DEVIATION REQUEST AND DECISION FORM

Project Name : Waterbury Filing No. 1
Schedule No.(s) : 4200000417
Legal Description : Waterbury Filing No. 1

A deviation from the standards of or in Section **DCM 10.5.4, 10.7, and DCM Update 9.0-9.1 per ECM 3.3.3.B.** is requested.

UNTIL SUCH TIME AS THESE
DRAWINGS ARE APPROVED
BY THE APPLICANT
TERRA NOVA ENGINEERING,
INC. APPROVES THEIR USE
ONLY FOR THE PROJECT
AND PURPOSES AUTHORIZED BY
WRITTEN AUTHORIZATION.

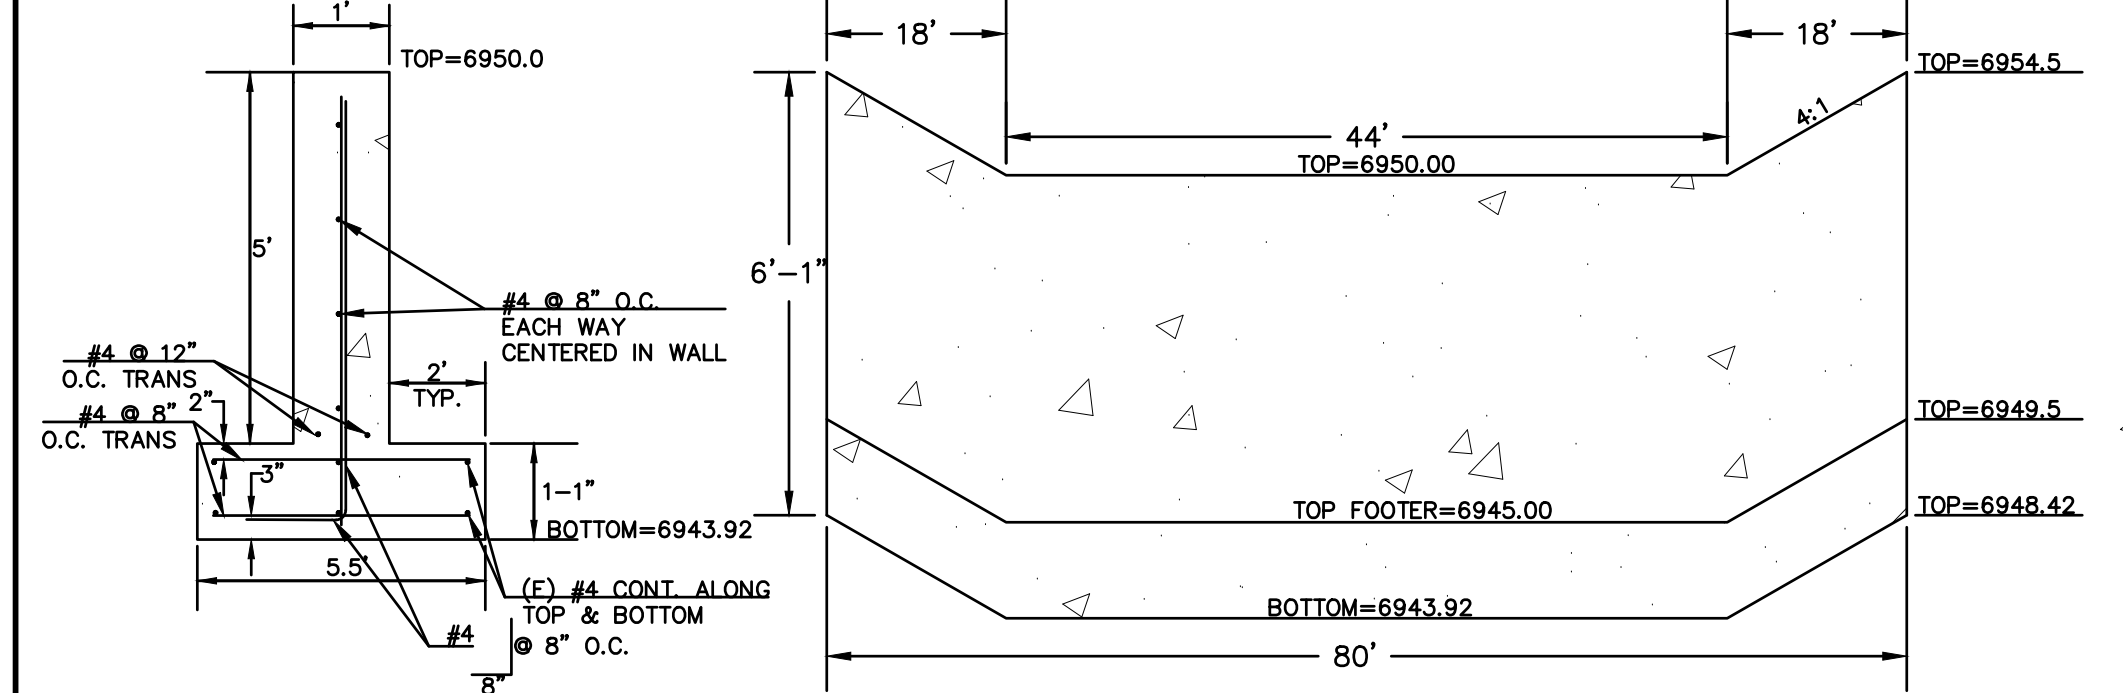
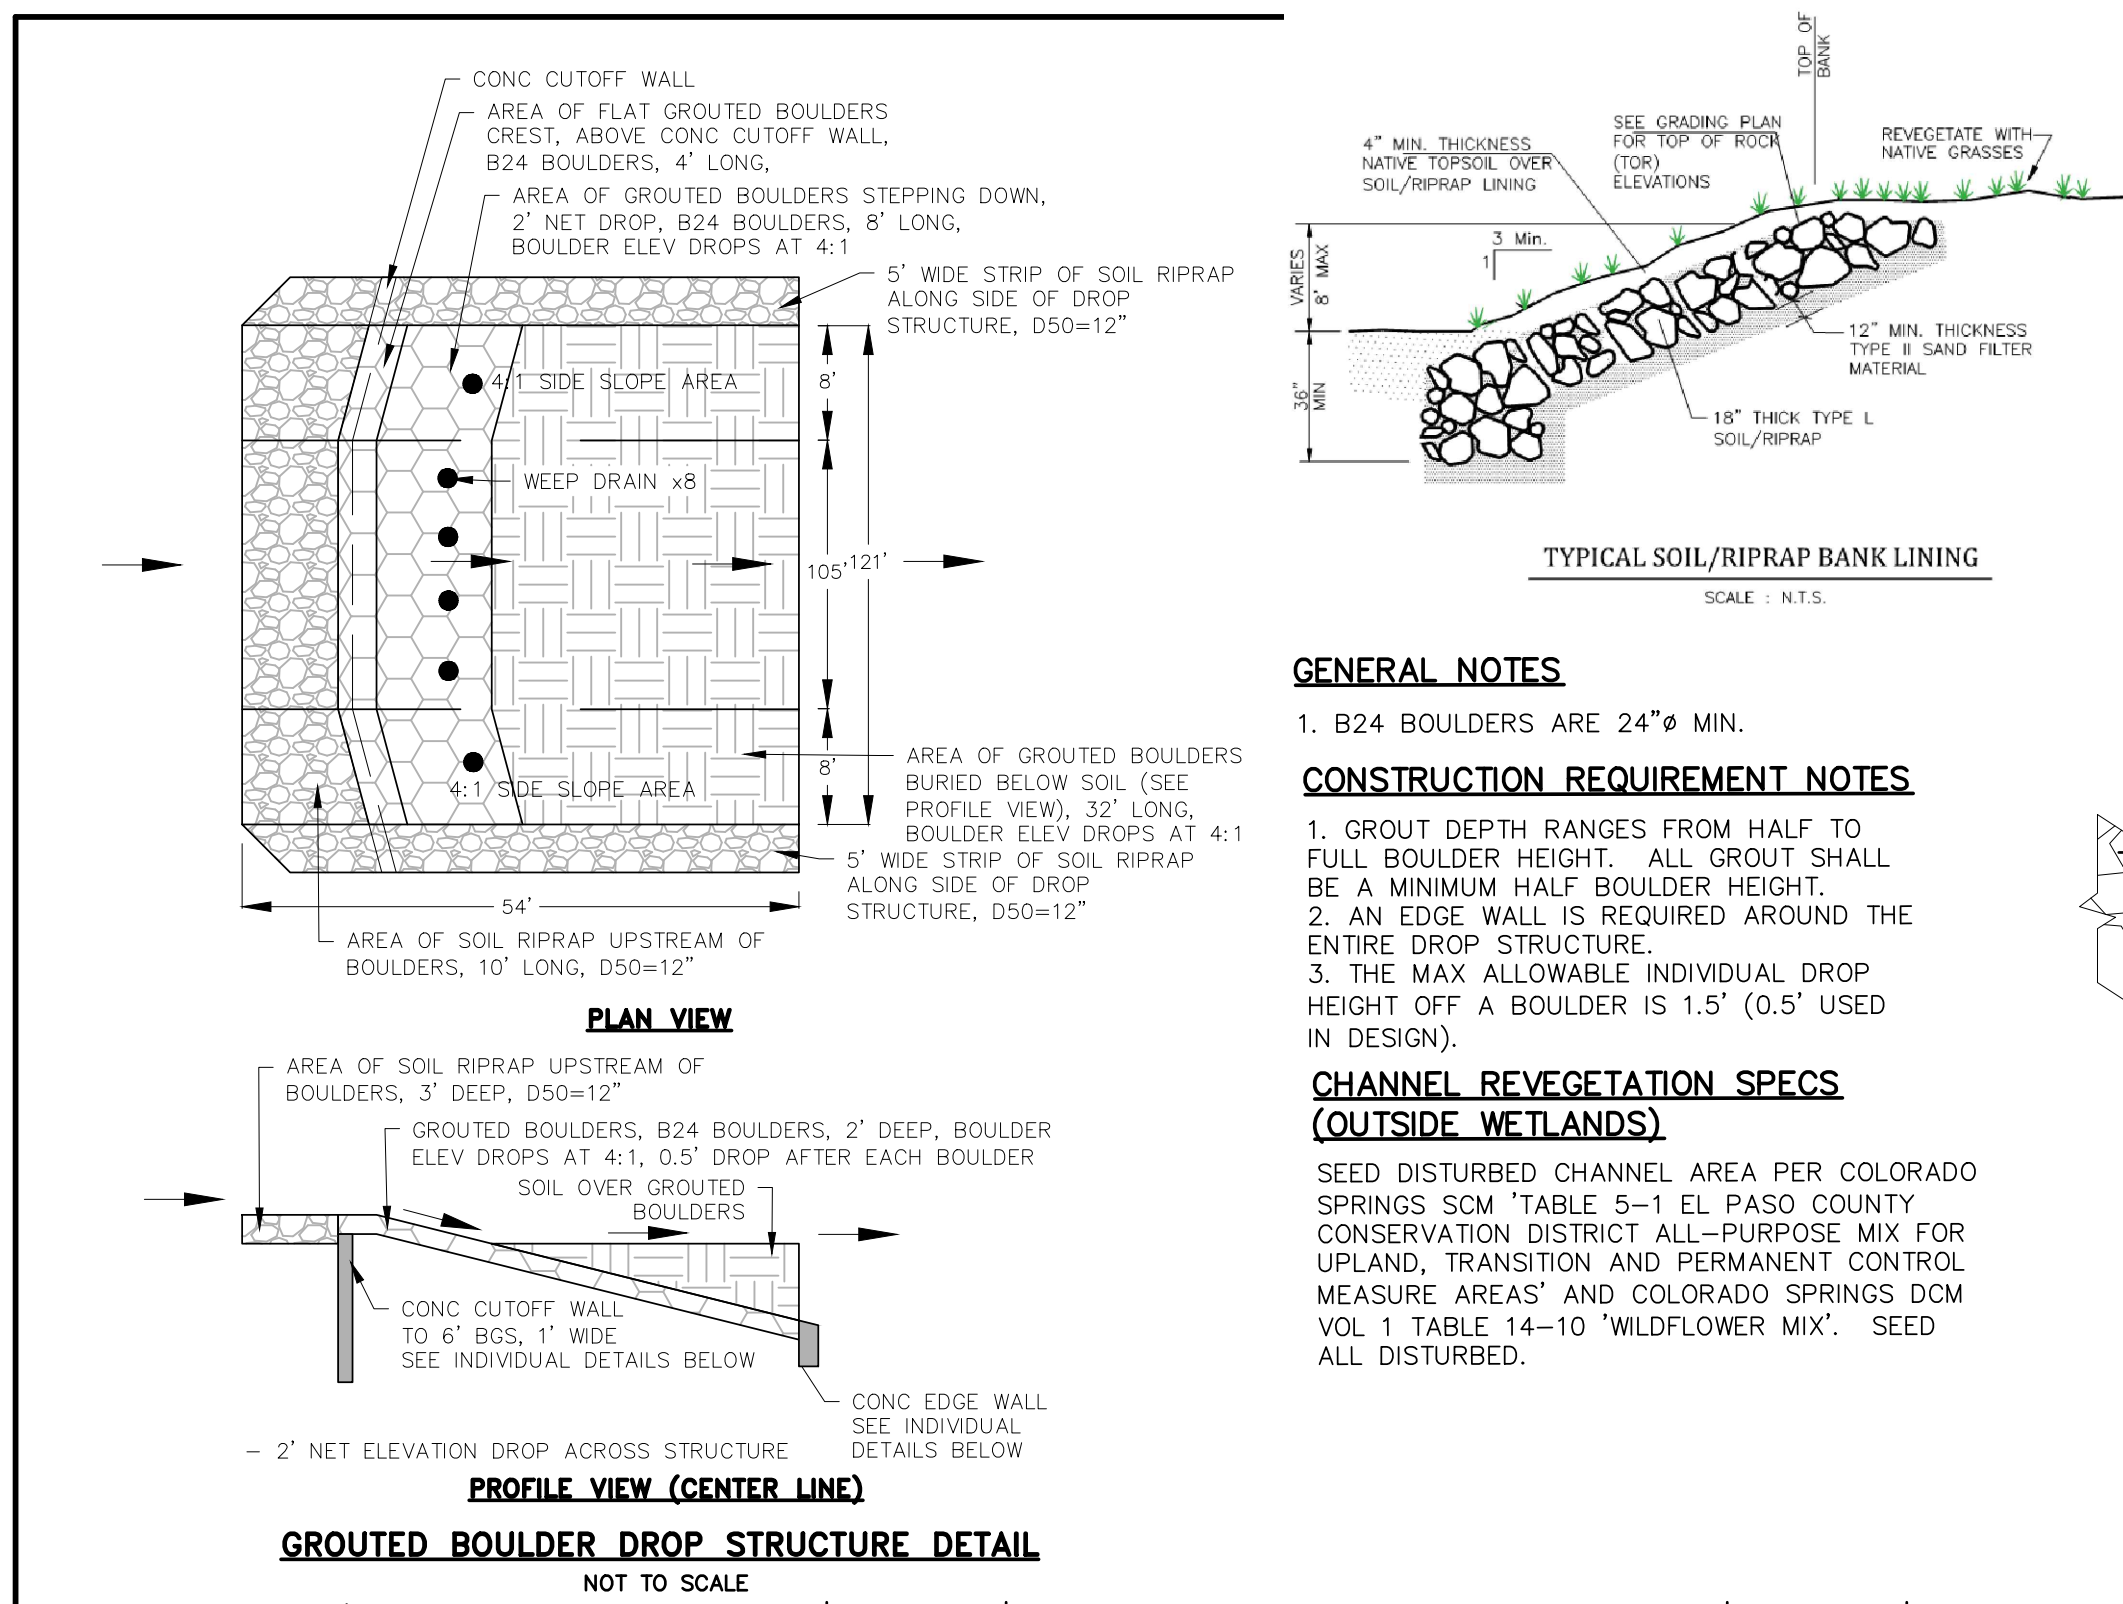
An alternate for the West Channel in the 100-Year event is to armor the channel sides, provide drop structures and plant cattails and palustrine emergent wetland vegetation. We are proposing to do just that with the construction drawings at these locations listed below in the 100-Year event.

In the 100-y event RS x-section **1820** is shown as supercritical the velocity is 5.06 fps, the Froude number is 0.91 and the shear stress is 2.63 lbs/sq ft, this cross section is at the top of a proposed grouted riprap drop structure with armoring on the sides and being re-vegetated. This is the proposed alternative to resolving the issue.

In the 100-y event RS x-section **1800** is shown as supercritical the velocity is 5.25 fps, the Froude number is 1.01 and the shear stress is 2.98 lbs/sq ft, this cross section is a proposed grouted riprap drop structure with armoring on the sides and being re-vegetated. This is the proposed alternative to resolving the issue.

In the 100-y event RS x-section **1420** is shown as supercritical the velocity is 4.00 fps, the Froude number is 1.01 and the shear stress is 2.07 lbs/sq ft, all below the erosive limits shown in Table 8.3 this cross section is a proposed grouted riprap drop structure with armoring on the sides and being re-vegetated. This is the proposed alternative to resolving the issue.

In the 100-y event RS x-section **350** is shown as supercritical the velocity is 5.25 fps, the Froude number is 1.01 and the shear stress is 8.09 lbs/sq ft, this cross section is a proposed grouted riprap drop structure with armoring on the sides and being re-vegetated. This is the proposed alternative to resolving the issue.

WATERBURY EAST CHANNEL PLAN & PROFILE VIEW
HORZ SCALE: 1"=100' - VERT SCALE: 1"=10'

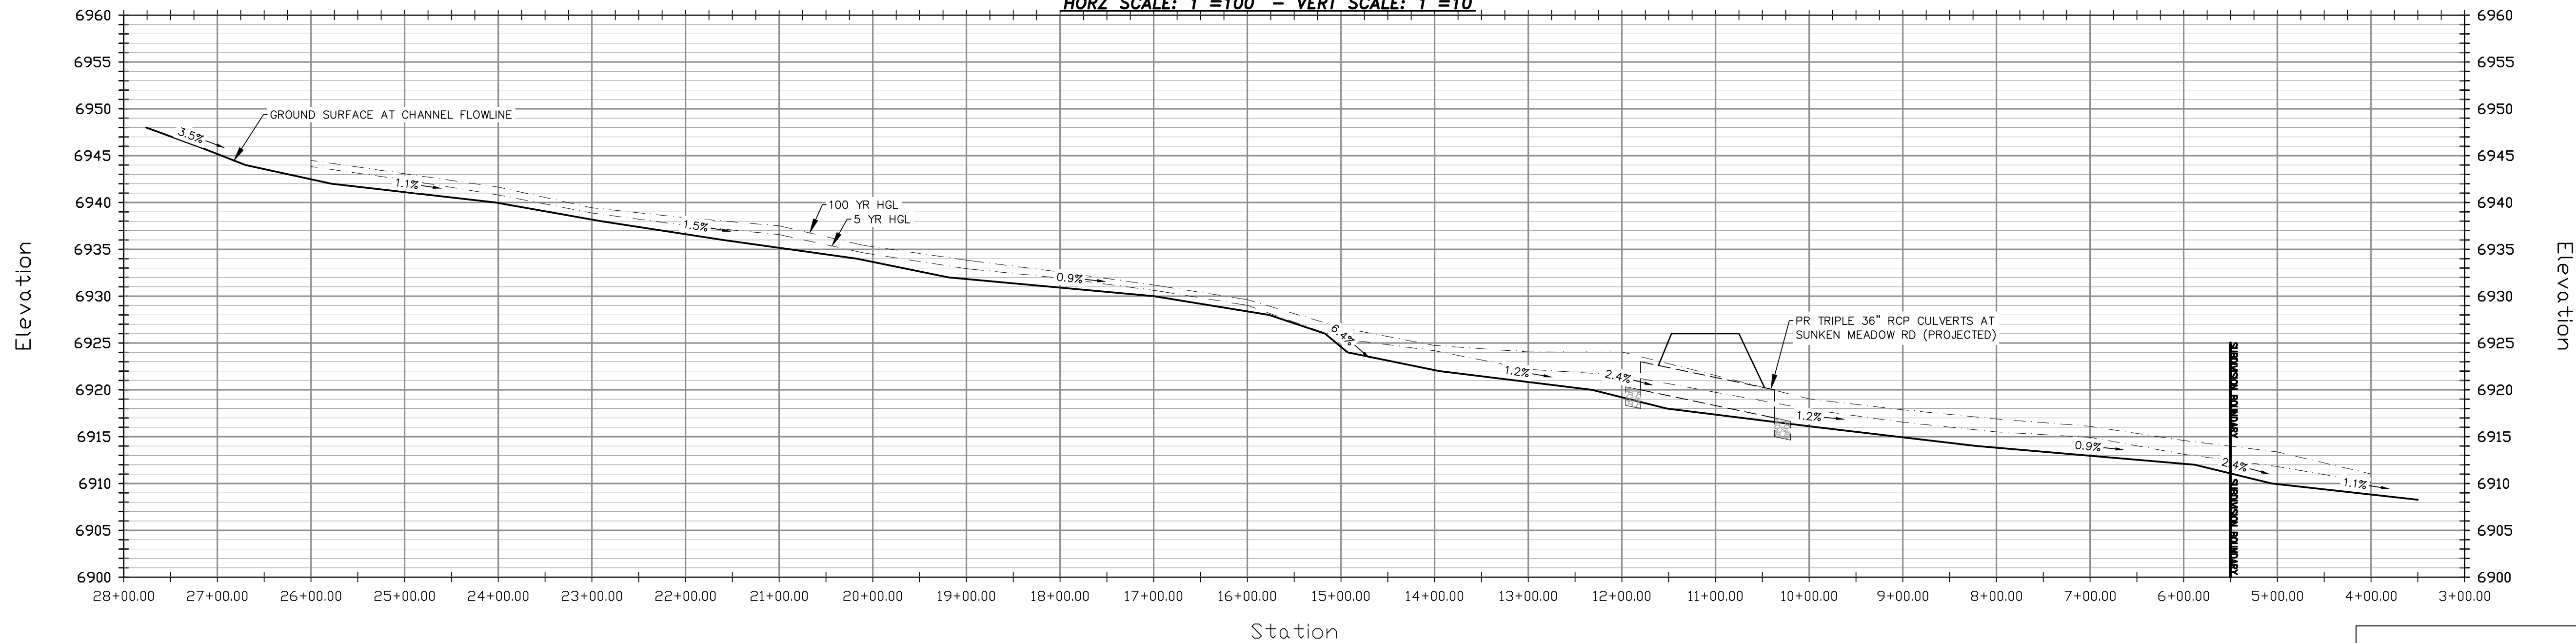
An alternate for the East Channel is to armor it or provide drop structures and we are arguing that we do not need to disturb the East Chanel due to the established wetlands and vegetation that currently show no signs of degradation from past storm events. In Walking the site with an El Paso County Engineer, the East Channel showed it is performing fine as it currently is.

The East channel has no supercritical RS x-sections in the 100-y event and 3 in the 5-y event (RS sections **2010.45, 1300, & 600**)

In the 5-y event RS x-section **2010.45** is shown as supercritical, the Froude number is 0.98 which is above the allowable 0.7 but the velocity is 3.34 fps and the shear stress is 2.63 lbs/sq ft, shows it is not erosive and with no shown degradation or erosion the proposed alternative is to leave it as.

In the 5-y event RS x-section **1300** is shown as supercritical, the Froude number is 0.98 which is above the allowable 0.7 but the velocity is 3.34 fps and the shear stress is 2.57 lbs/sq ft, shows it is not erosive and with no shown degradation or erosion the proposed alternative is to leave it as.

In the 5-y event RS x-section **600** is shown as supercritical, the Froude number is 0.92 which is above the allowable 0.7 but the velocity is 3.79 fps and the shear stress is 2.57 lbs/sq ft, shows it is not erosive and with no shown degradation or erosion the proposed alternative is to leave it as.
